PL202200086

Creekridge I
7807 Creekridge Circle

Expand existing deck for Additional exits on east side of building

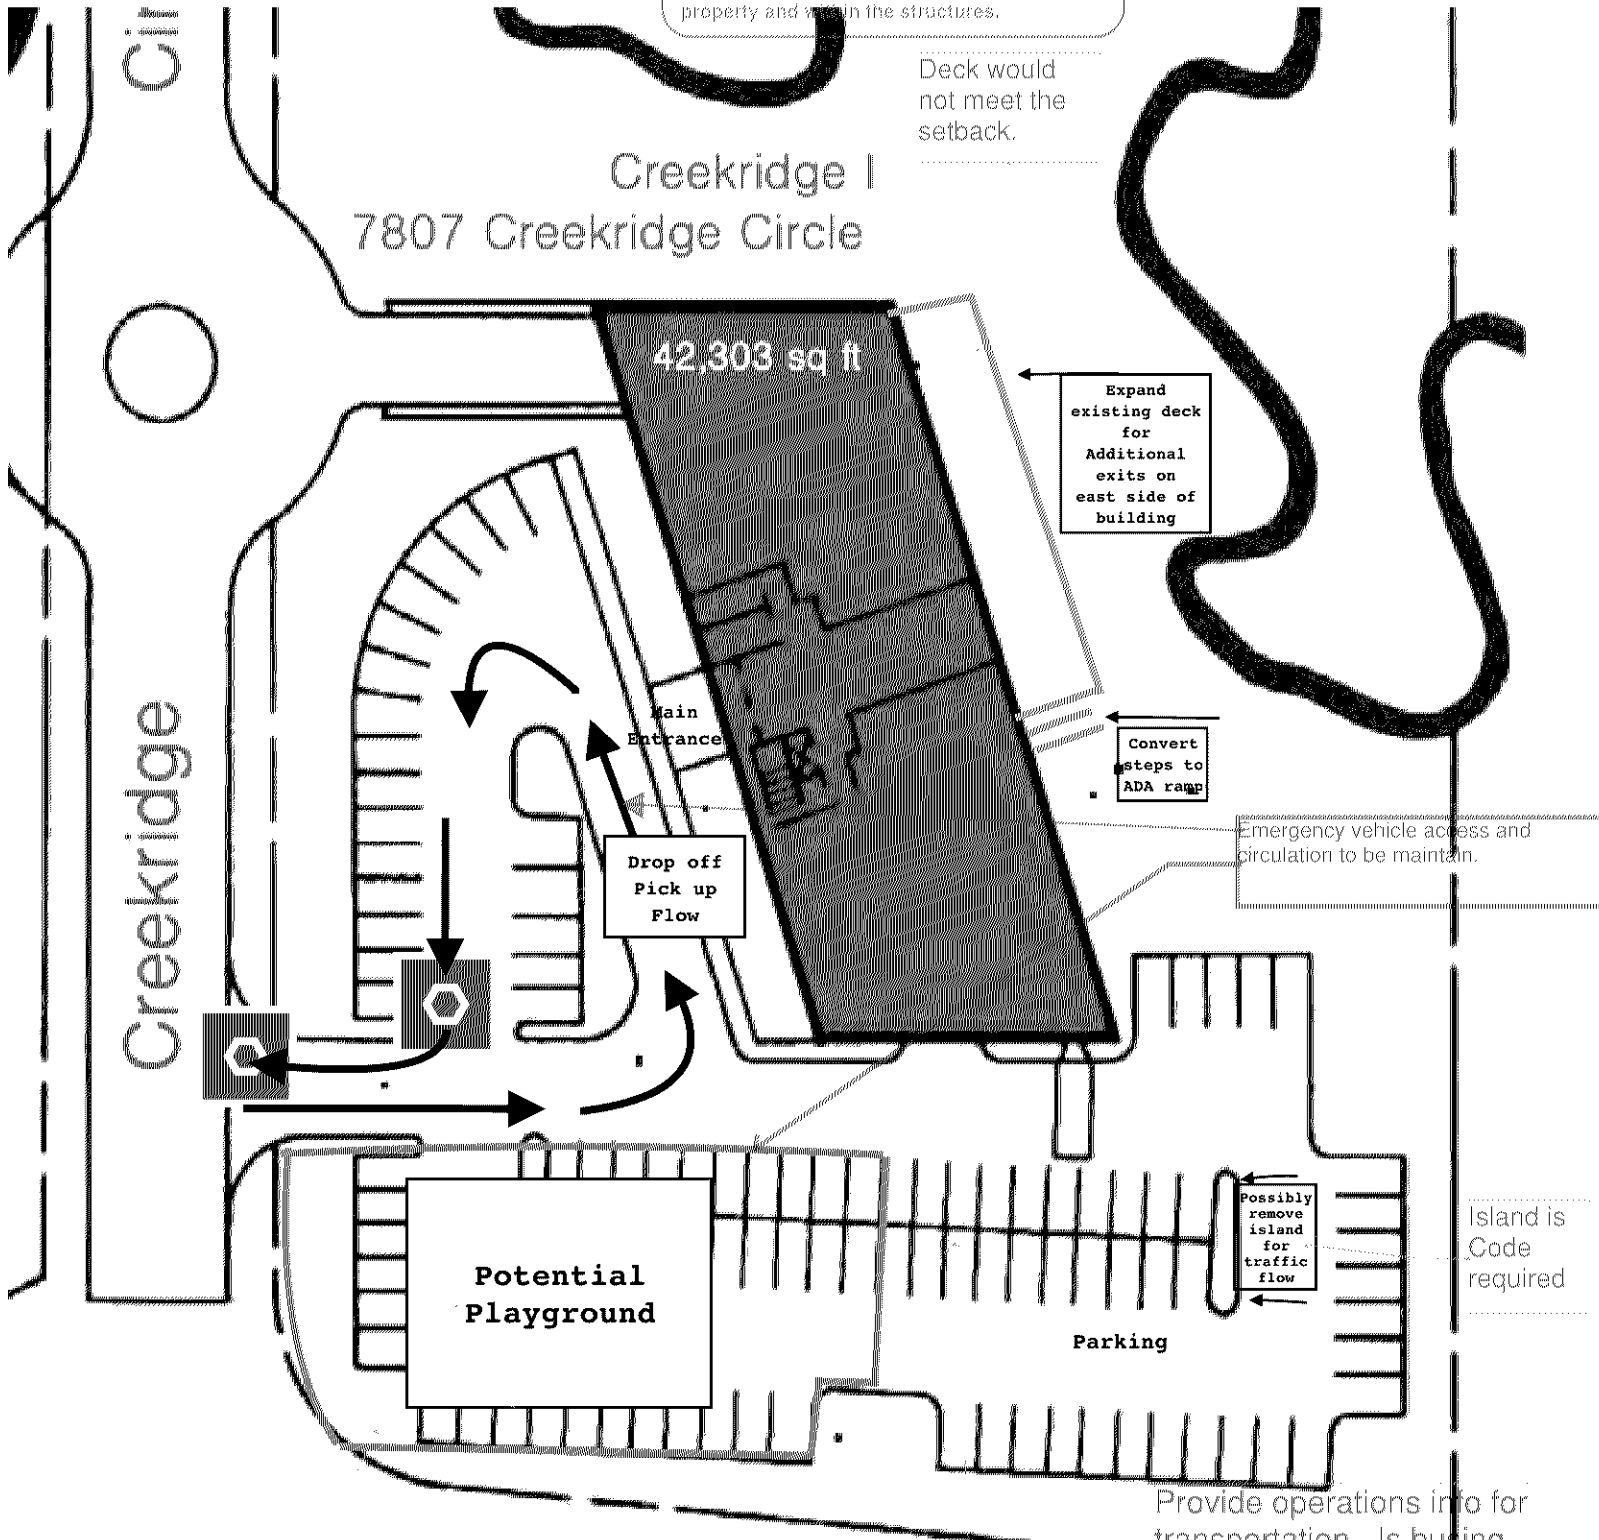
Building property shall be adequately signed for emergency response.

Provide adequate turning radius for all emergency vehicle access lanes.

Show property and easement lines.

Emergency responder radio coverage meeting the requirements of appendix L in the 2015 MSFC shall be provided throughout the property and within the structures.

Deck would not meet the setback.

Emergency vehicle access and circulation to be maintain.

Possibly remove island for traffic flow

Island is Code required

More detail required. Yard area must be maintained.

Circulation must be provided and must include an island

Provide operations info for transportation. Is busing provided? Layout should provide separated drop off and pickup between buses and parent traffic. Estimate and accommodate for parent traffic queue.

1ST FLOOR • 11,660 RSF

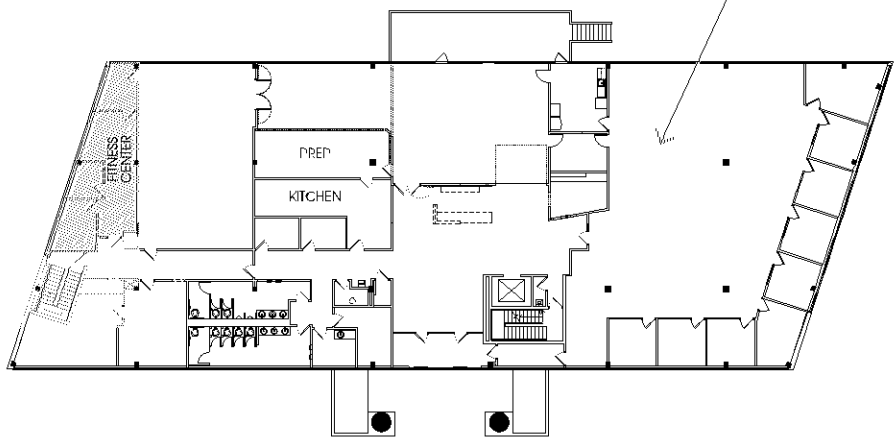
Cafeteria to meet 2020 MN Building Code for exiting requirements.

Provide an Environmental Health Plan Review application with plan submittal for each proposed food facility.

Any additions or changes to food service must be approved by the Health Department prior to construction if required.
